MEMORANDUM

To: The Design Advisory Board
From: Mary O'Neil, AICP, Principal Planner
RE: 273 Pearl Street, 11, 15 and 21 Hungerford Terrace
ZP20-0717CA/MA, ZP20-0718CA, ZP20-0719CA, ZP20-0720CA.
First DAB meeting: July 14, 2020
Revised Plans received: August 7, 2020
Date: August 25, 2020

Request: Planned Unit Development to include demolition of a single family home at 15 Hungerford Terrace and a garage at 11 Hungerford Terrace; demolish south porch and move garage at 21 Hungerford Terrace; construct 12 unit residential building. Net new new units = 11 (if earlier duplex approvals are relinquished.) Site changes, including retaining walls. Parking changes with 17 space parking waiver request (42% of required residential parking.)

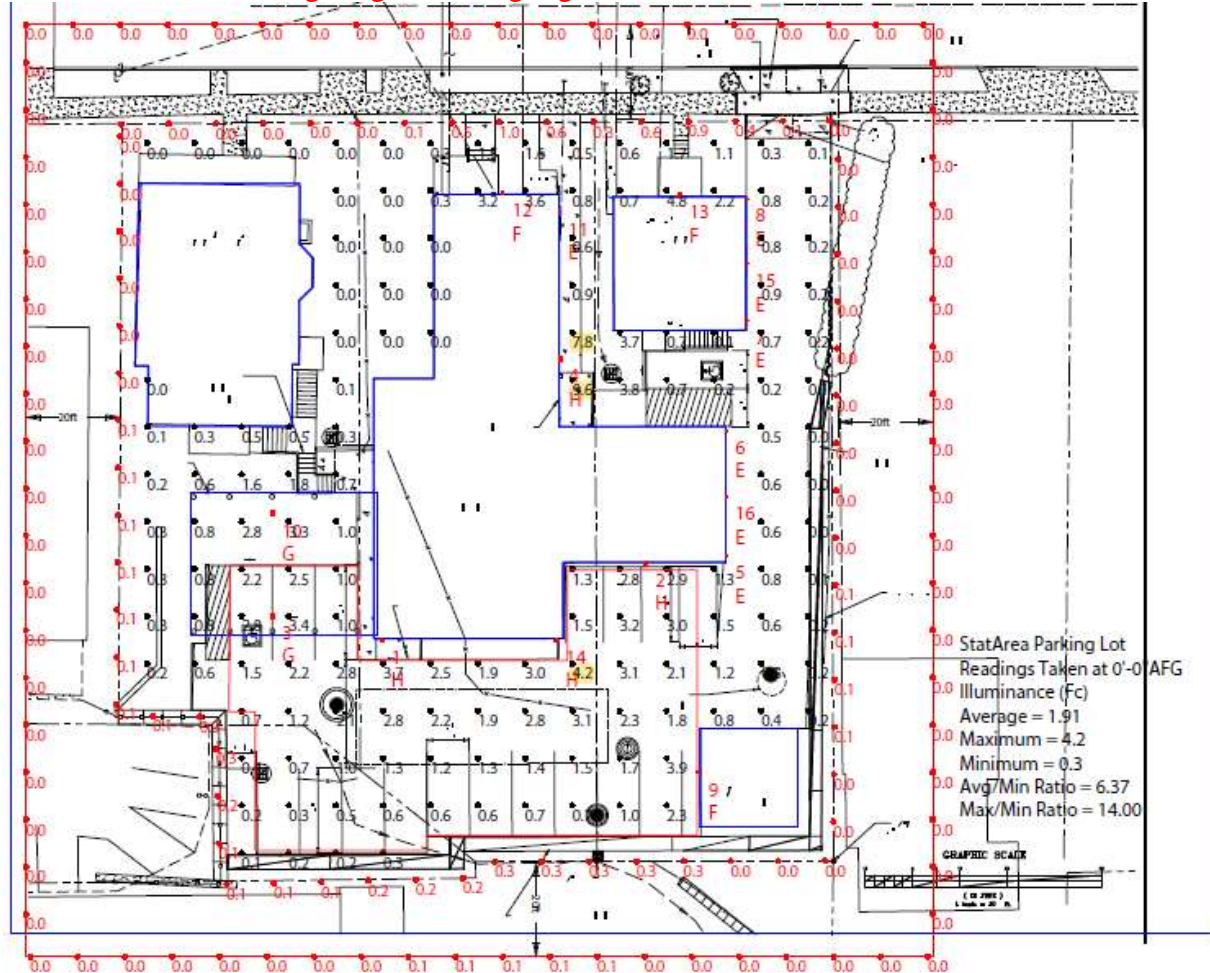
Civil plans C2.2 and C4.2 and Plan A8 define the gravity wall as terraced with plantings.

Heights vary from 2-12’. As the involved properties all sit on the cusp of the Burlington Ravine and have consistently struggled with the changing grade inherent to their site, this is the context of the neighborhood. Review of retaining walls greater than 3’ in height is the responsibility of the City Engineer.
